TVA-SQN-TS-03-12

SEQUOYAH NUCLEAR PLANT (SQN) UNITS 1 AND 2 TECHNICAL SPECIFICATIONS (TS) CHANGE 03-12, APPLICATION FOR TECHNICAL SPECIFICATION IMPROVEMENT TO EXTEND THE COMPLETION TIME FOR ACTION A OF TECHNICAL SPECIFICATION 3/4.5.1, 'ACCUMULATORS,' USING THE CONSOLIDATED LINE ITEM IMPROVEMENT PROCESS (CLIIP)

Proposed Technical Specification Changes (mark-up)

3/4.5.1 ACCUMULATORS

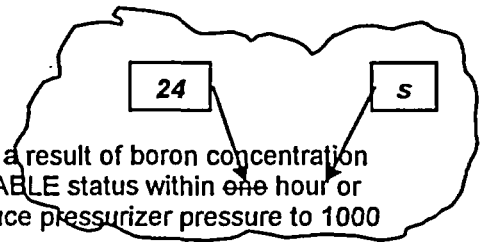
The proposed amendment would extend the completion time from 1 hour to 24 hours for "Action a" of TS 3/4.5.1, "Accumulators." The change is consistent with Nuclear Regulatory Commission approved Industry/Technical Specification Task Force (TSTF) Standard Technical Specification Change Traveler, TSTF-370, "Risk Informed Evaluation of an Extension to Accumulator Completion Times for Westinghouse Plants." The availability of this TS improvement was announced in the *Federal Register* on March 12, 2003, as part of the CLIIP.

- a. With one cold leg injection accumulator inoperable, except as a result of boron concentration not within limits, restore the inoperable accumulator to OPERABLE status within one hour or be in at least HOT STANDBY within the next 6 hours and reduce pressurizer pressure to 1000 psig or less within the following 6 hours.
- b. With one cold leg injection accumulator inoperable due to the boron concentration not within limits, restore boron concentration to within limits within 72 hours or be in at least HOT STANDBY within the next 6 hours and reduce pressurizer pressure to 1000 psig or less within the following 6 hours.

The proposed License amendment extends the completion time from 1 hour to 24 hours for "Action a" of Technical Specification (TS) 3/4.5.1, "Accumulators."
